**Subject: Sabre Springs/Peñasquitos Bus Rapid Transit Center Addendum
to the Sabre Springs Transit Center Final Initial Study/Mitigated
Negative Declaration**

**ADDENDUM TO THE
SABRE SPRINGS TRANSIT CENTER
FINAL INITIAL STUDY/MITIGATED NEGATIVE DECLARATION
DECEMBER 2004**

Site Plan

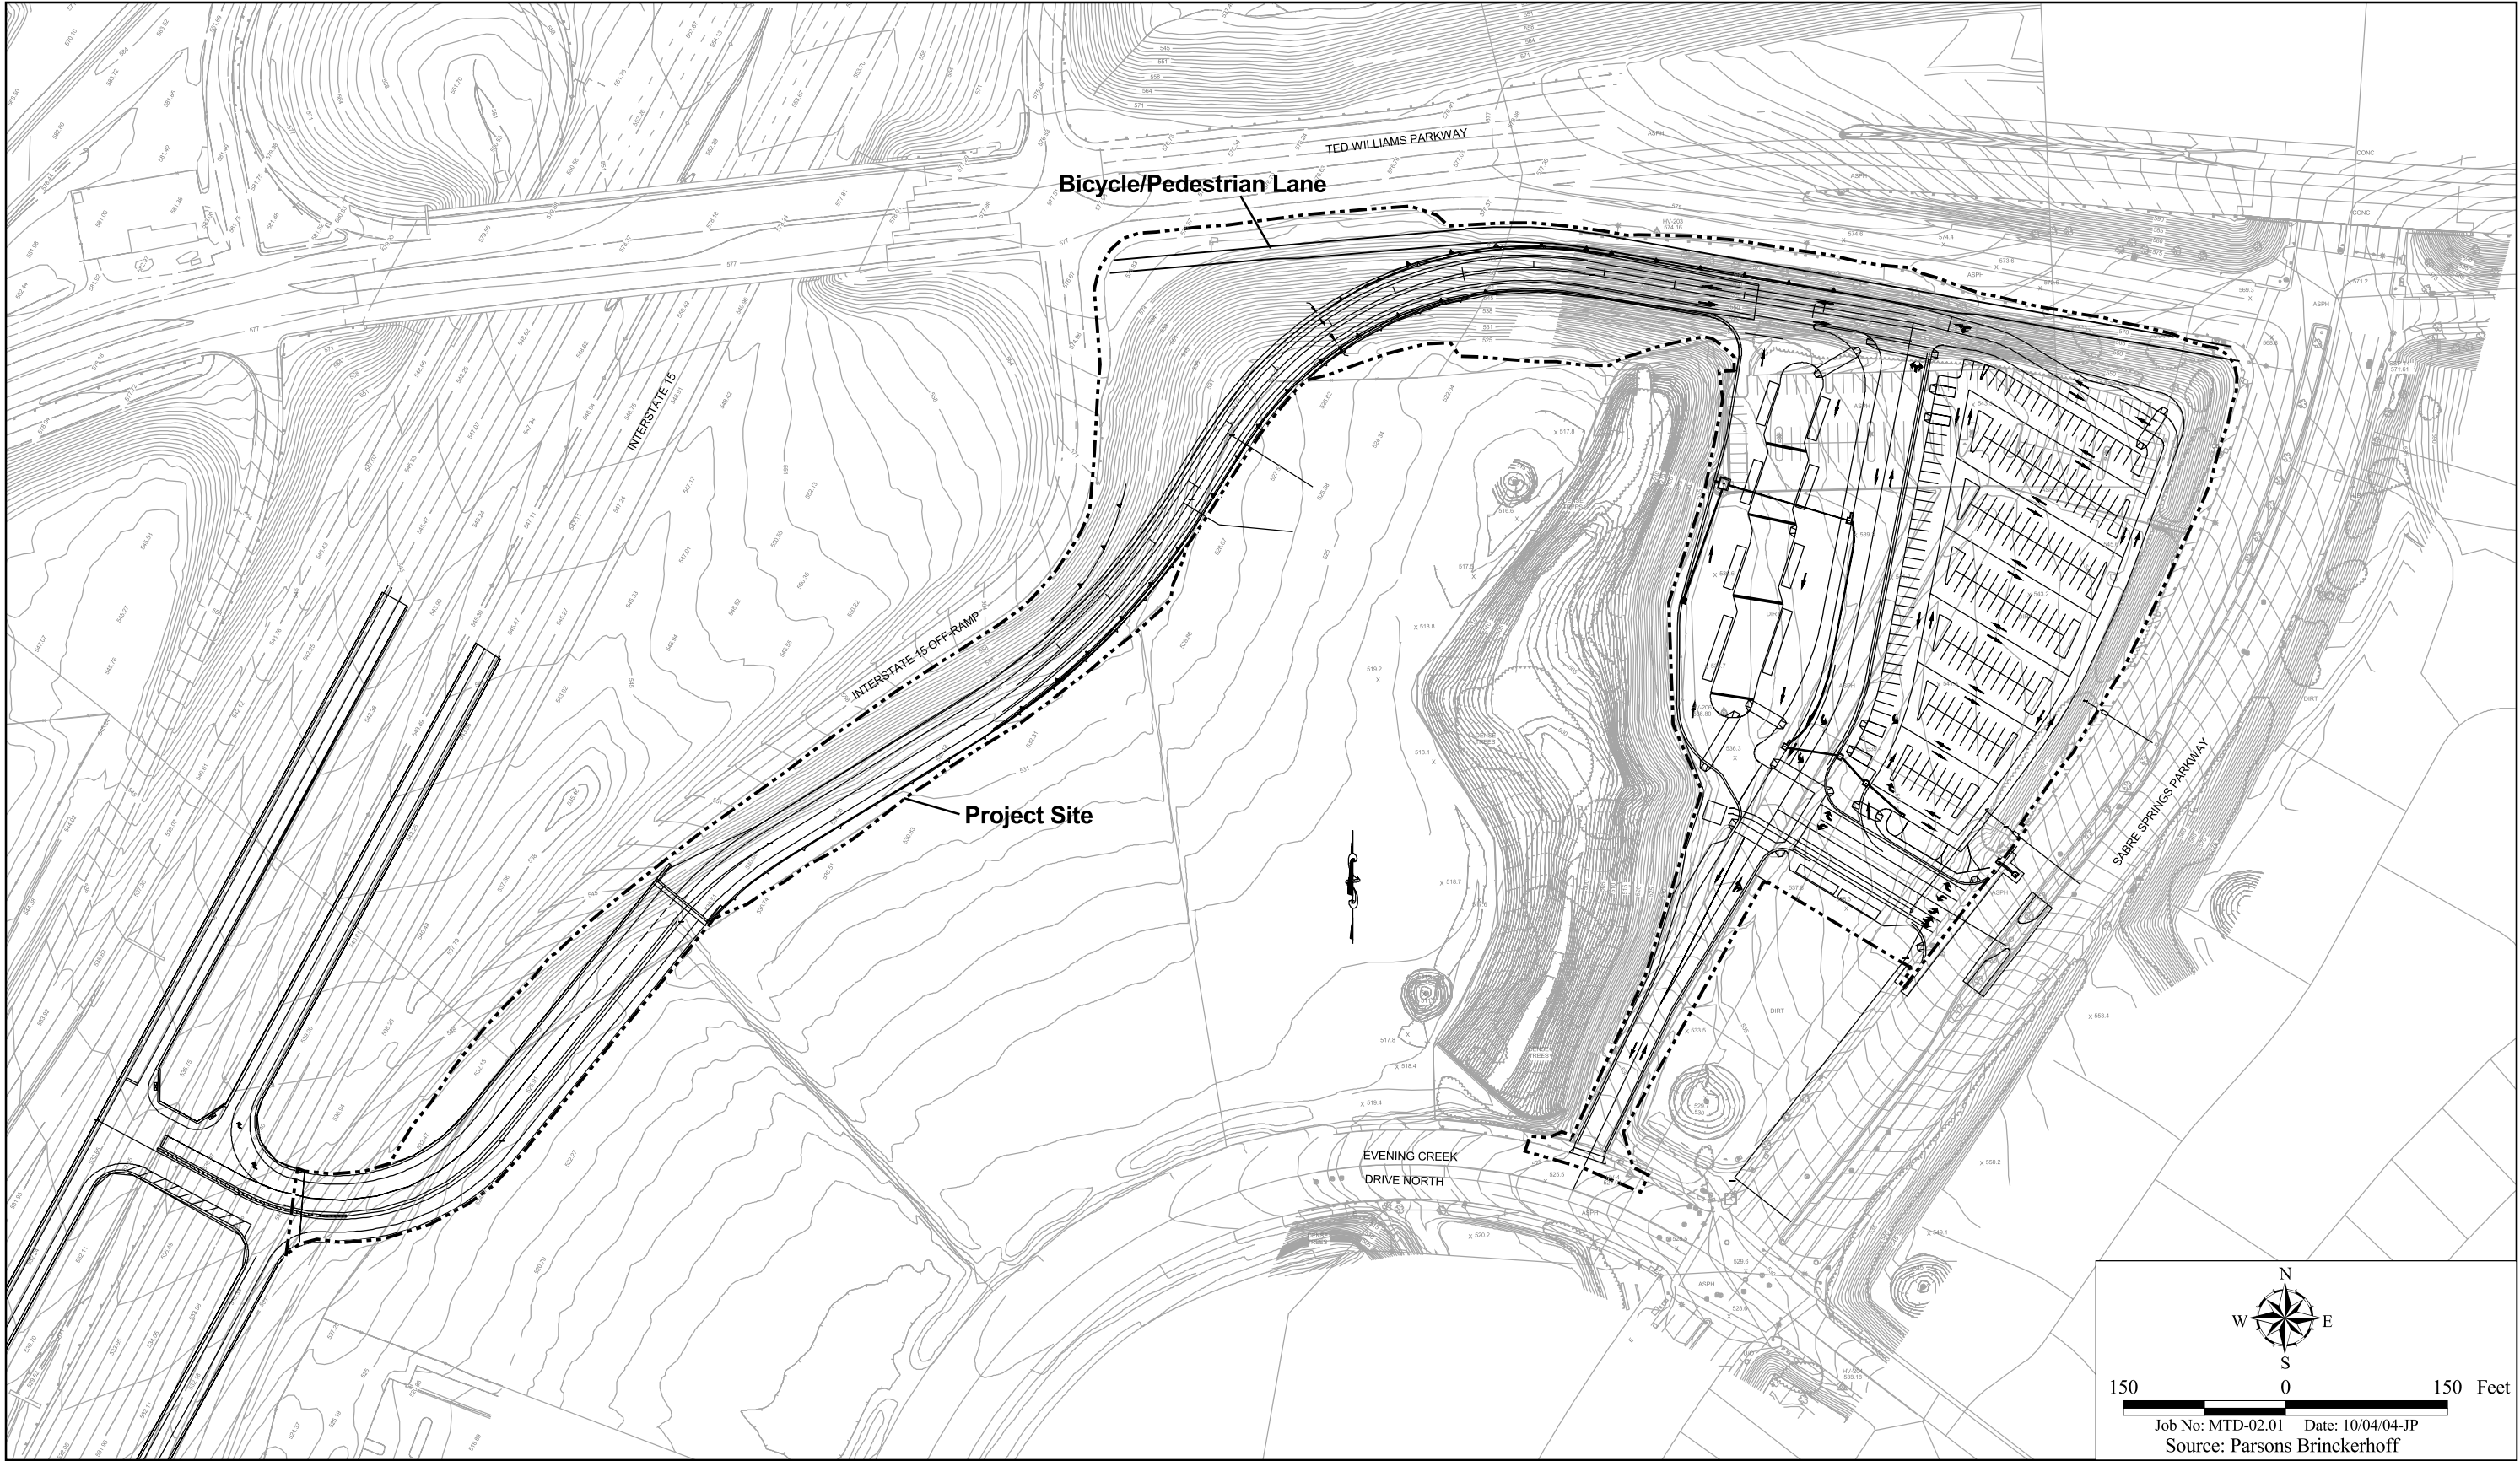
The proposed transit center would consist of ten bus bays, an approximately 200-vehicle park-and-ride lot, a kiss-and-ride drop-off area, a bicycle/pedestrian path, a communications building, transit-related furnishings, and an access road connecting the transit center to I-15 (Figure 3). Caltrans would build the access road, which would connect to a proposed Direct Access Ramp (DAR) to be constructed in conjunction with the Caltrans' I-15 Managed Lanes project. The DAR would provide direct access to and from I-15 high occupancy vehicle (HOV) lanes and is not part of the proposed project. Caltrans would also construct a proposed bicycle/pedestrian path, which would consist of a 12-foot-wide, asphalt concrete path immediately south of Ted Williams Parkway, extending along the I-15 off-ramp and terminating at Sabre Springs Parkway. A passenger platform area with eight bus bays (six standard and two articulated) would be located in the northwestern portion of the facility and another passenger platform with two pull-through standard bus bays would be located along the access off of Sabre Springs Parkway to accommodate local bus routes. A park-and-ride lot would be located east of the main bus area and would provide approximately 200 parking spaces (including six ADA-accessible spaces). Pedestrian crossings and curb ramps would be provided to connect the passenger platform areas with the park-and-ride lot. A kiss-and-ride drop-off area would be provided along the west side of an internal roadway. An approximately 225-square foot communications building would be constructed as part of the facility and would house communication equipment, a mechanical equipment room, and a private restroom. The building would consist of concrete masonry with a sloped, metal roof and would be 8 to 12 feet above grade. Transit furnishings would include canopies and benches within the main platform area. Overhead lighting would also be installed, where appropriate, to provide adequate lighting during early morning and nighttime operations. A retaining wall would be constructed by Caltrans along the north side of the proposed access road from the transit center to the DAR. The wall would vary in height with a maximum of 26 feet and would be cast-in-place (Caltrans Type 1) with an architectural finish.

Proposed circulation improvements would include provision of two vehicular access points; installation of a traffic signal at the intersection of the Sabre Springs Parkway and the transit center; installation of a traffic signal interconnect system on Sabre Springs Parkway between Ted Williams Parkway and Evening Creek Drive; modifications to the existing median on Sabre Springs Parkway at the proposed transit center access point; provision of several vehicular travel lane configurations at the proposed access points and within the transit center; and construction of an access road between the transit

This addendum addresses proposed modifications to the design of the Sabre Springs/Peñasquitos BRT Center. The proposed modifications would include a reconfiguration of the layout of the BRT Center, the addition of a bicycle/pedestrian path, the addition of a proposed communications building, and off-site roadway improvements to Sabre Springs Parkway.

Previous Site Plan

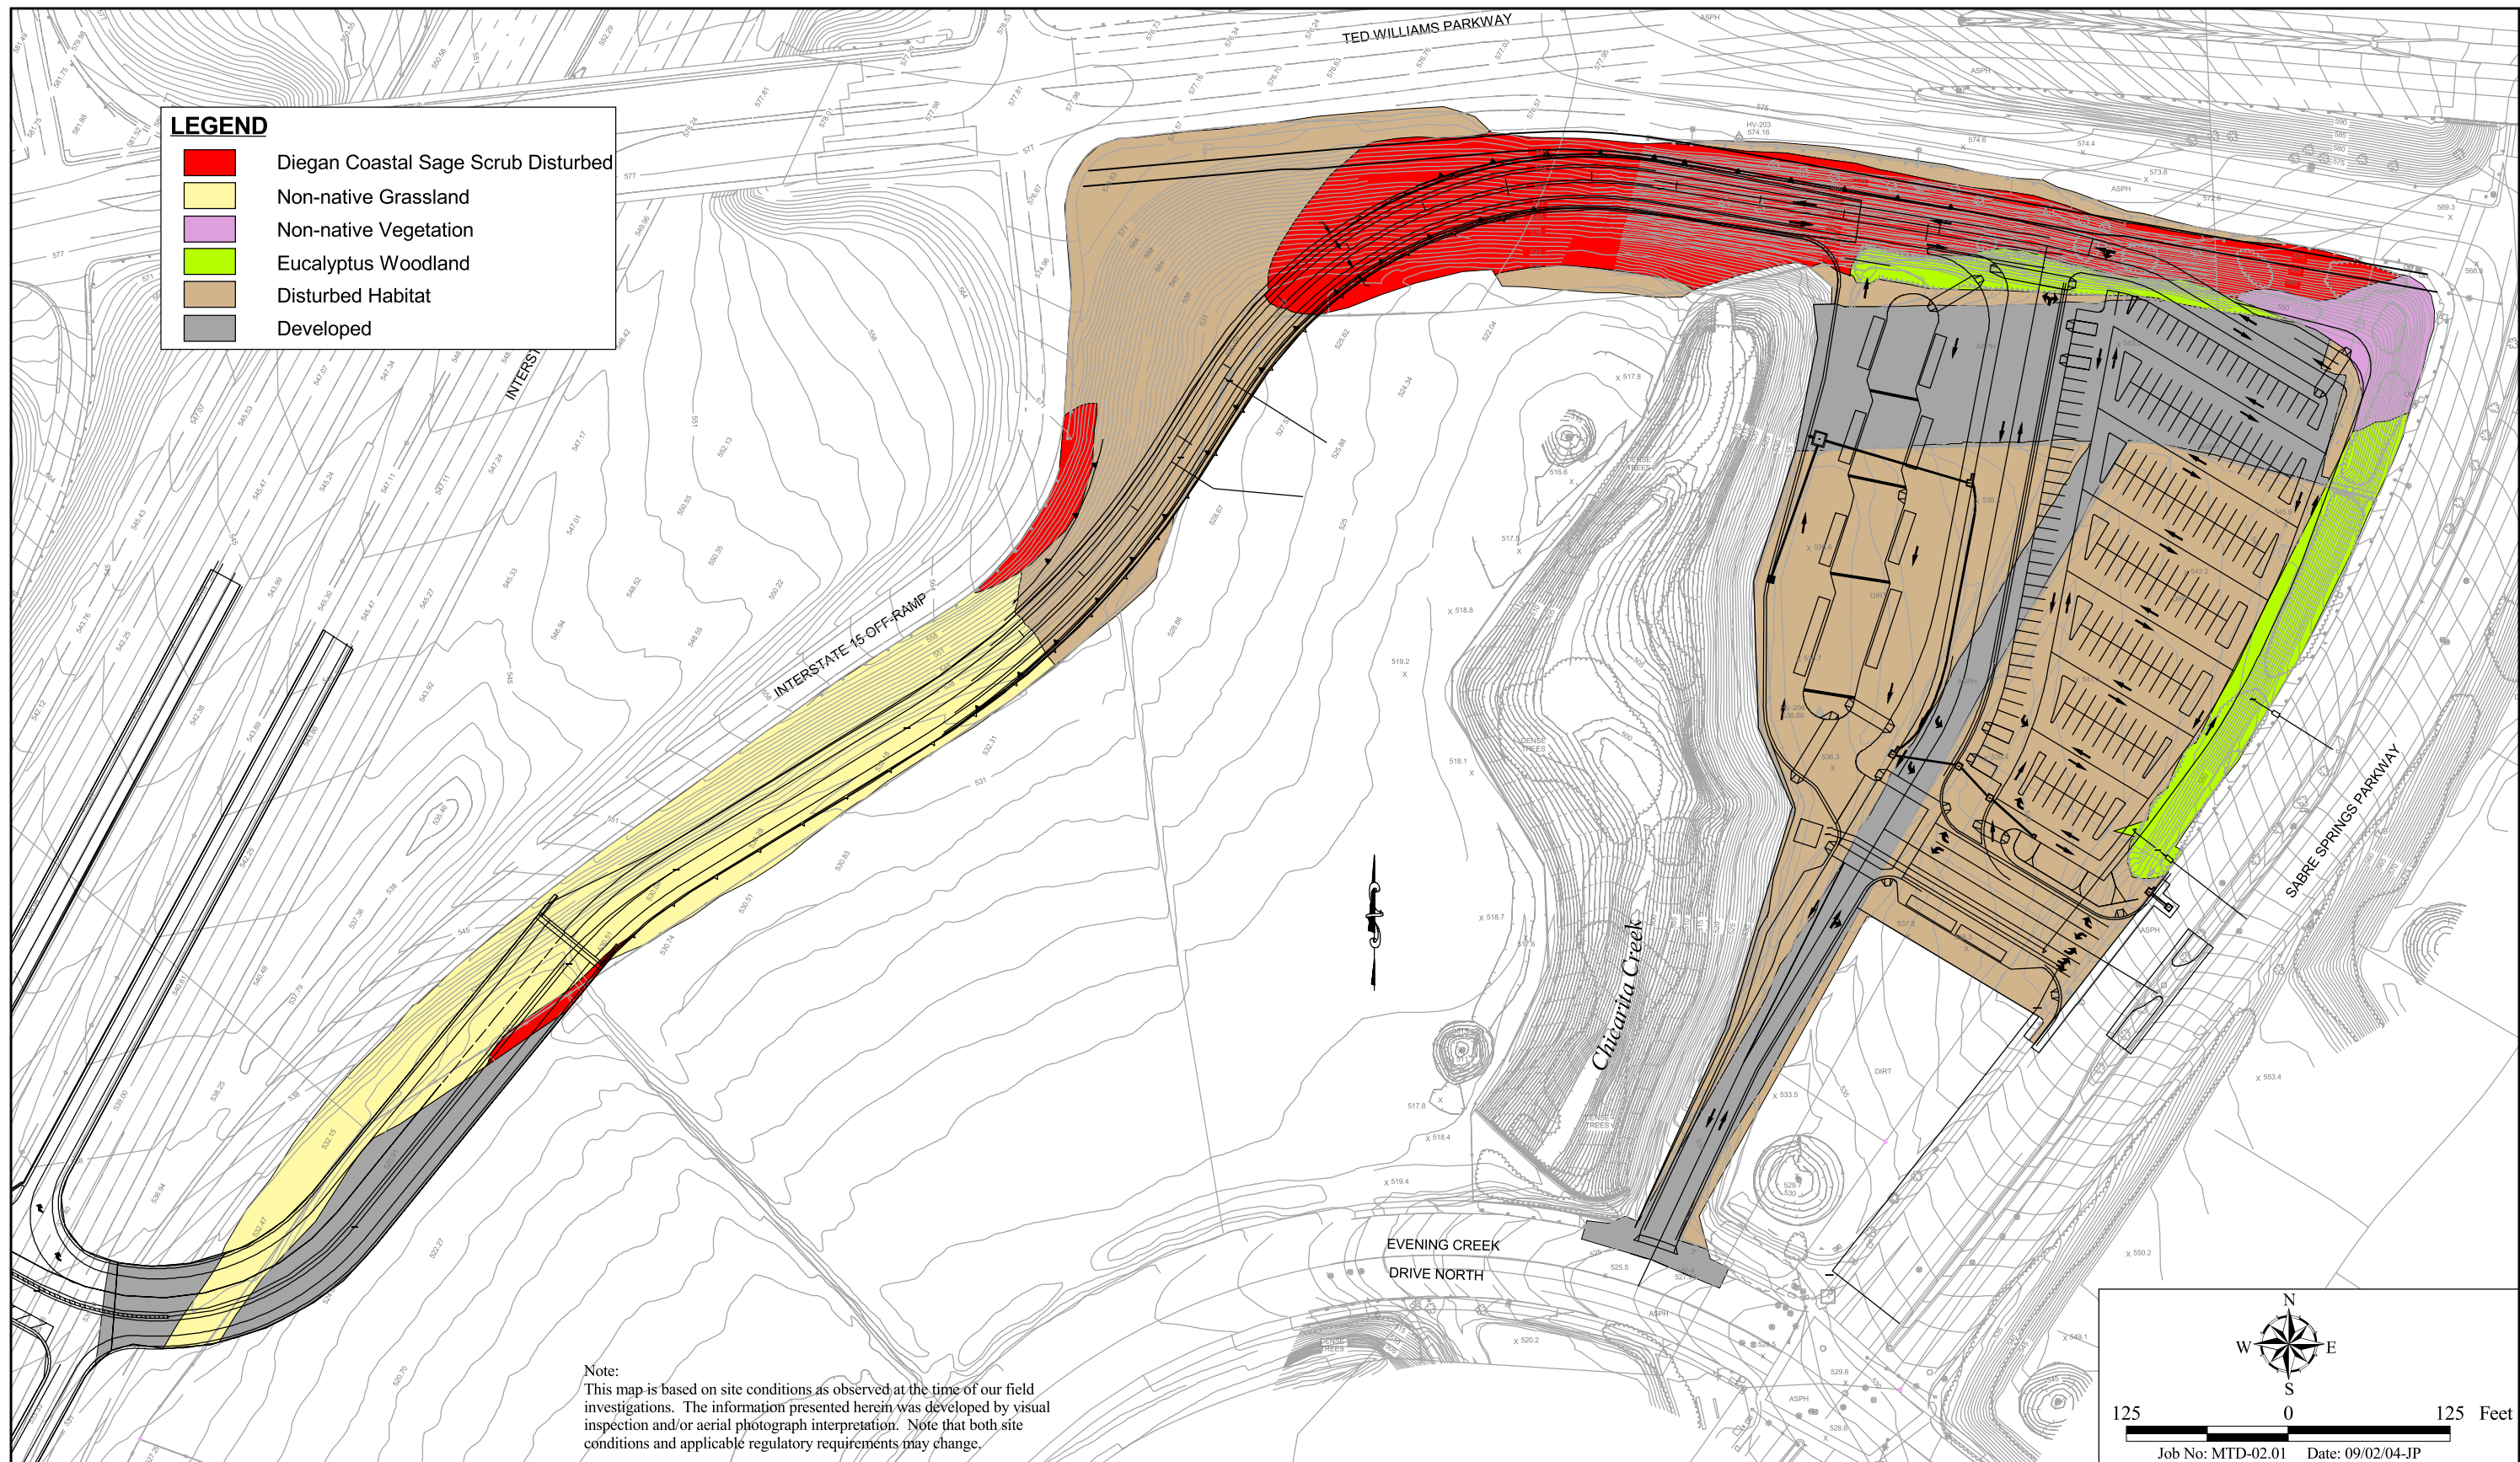
The BRT Center, as described in the Final IS/MND, included a park-and-ride lot in the western portion of the site and a bus platform area in the eastern portion of the property, adjacent to Sabre Springs Parkway (Figure 4). The proposed BRT Center has been modified such that the locations of these two components of the project have switched. The park-and-ride lot would be located in the eastern portion of the transit center and the bus platform area would be located in the western portion of the transit center. The BRT Center, as described in the Final IS/MND, would include another bus platform area with two pull-through bus bays along the internal roadway. These two bus bays have been relocated along the south side of the access off Sabre Springs Parkway.

Internal circulation routes within the transit center have been modified to accommodate the reconfigured BRT Center. The central internal roadway described in the Final IS/MND extended northeasterly from Evening Creek Drive to the DAR access road in a relatively linear alignment (Figure 4). The alignment of this roadway has been modified to extend northeasterly from Evening Creek Drive to the internal intersection and then northerly to the DAR access road. Due to the relocation of the park-and-ride lot in the eastern portion of the BRT Center, an exclusive right-turn access into the park-and-ride lot would be provided along the main BRT Center access off of Sabre Springs Parkway.

The location of the kiss-and-ride drop-off area was shown in the Final IS/MND within the park-and-ride lot in the western portion of the site (Figure 4). The proposed BRT Center also would include a kiss-and-ride drop-off area; however, it would be located along the west side of the central internal roadway, just south of the internal intersection.
